REMARKS

VERSION WITH MARKINGS TO SHOW CHANGES MADE

FIG.3

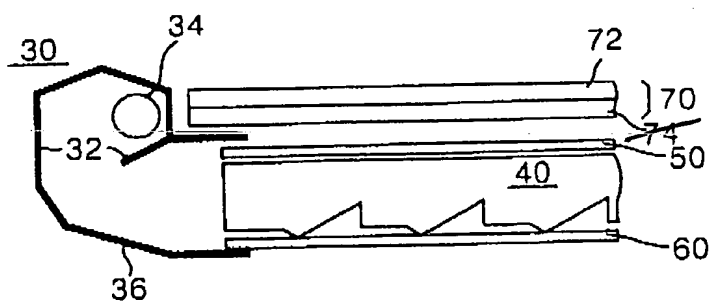
A drawing correction authorization request (DCAR) is being submitted concurrently herewith to delete reference sign 74 from Fig. 3.

The Examiner has objected to the Specification because reference signs 60 and 74 are shown in Fig.3 and not mentioned in the description. In response to the Examiner's objection, reference sign 74 has been deleted from Fig. 3 (see DCAR) and the specification has been amended to include reference sign 60. Reconsideration and withdrawal of this objection are respectfully requested.

--Referring to Fig. 3, there is shown a back light unit according to an embodiment of the present invention. The back light unit includes a light input 30 directing a light path of a light beam into the rear side thereof to achieve high focusing of the light beam, and a light-guide plate 40 for progressing the light beam from the light input 30 in the vertical direction of a liquid crystal panel. The light input 30 directs a light path of a light beam into the rear side to narrow a range of an incidence angle in the vertical direction of a light beam incident to the light-guide plate 40, thereby achieving high focusing of the light beam. A reflective plate 60 is additionally installed below the light-guide plate 40 and reflects a light beam progressing downwardly from the light guide plate 40 toward the liquid crystal panel.
